CHIME
ELEMENTARY SCHOOL

2/17/98 BID PACKAGE

A1-00/BP-1

BID PACKAGE 1	ADDENDUM # 1	REFERENCE SHEET A1-01
ASK 8	2/20/98 3/10/98	CHIME ELEMENTARY SCHOOL Oshtemo, Michigan Eckert/Wordell Architects 161 East Michigan Ave • Kalamazoo, MI 49007 616 388 7313 616 388 7330 Fax

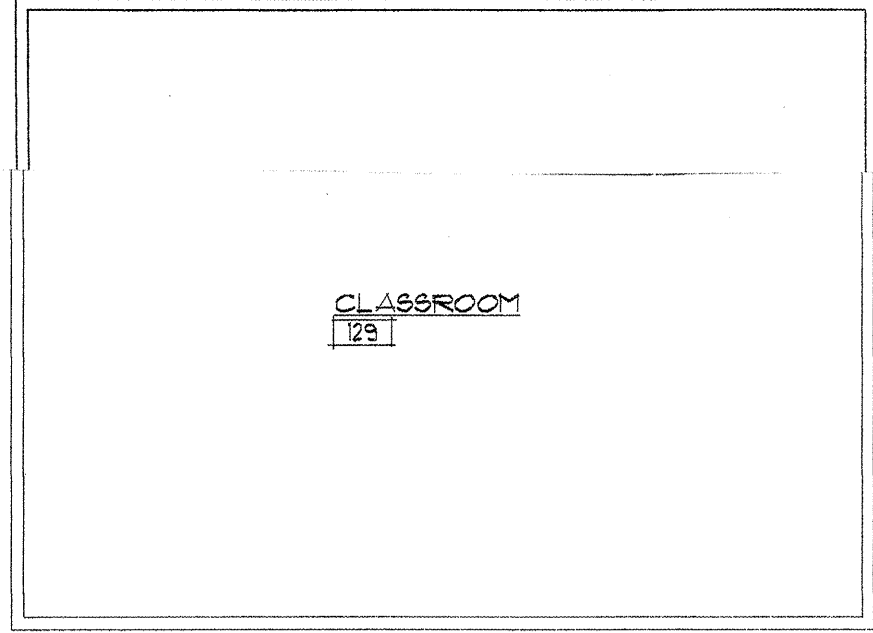
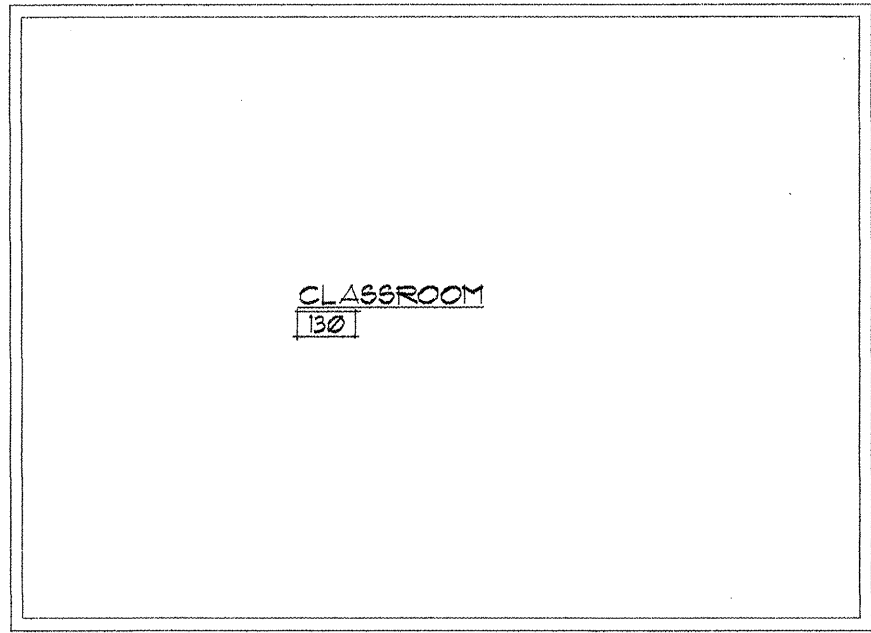
Existing window to remain in
 classroom 110 as per Ask-1
 2 The owner will test the opaque window
 Panels. If these panels are found to
 contain asbestos the owner will abate

EXISTING DOOR AND SIDELIGHT
 TO REMAIN
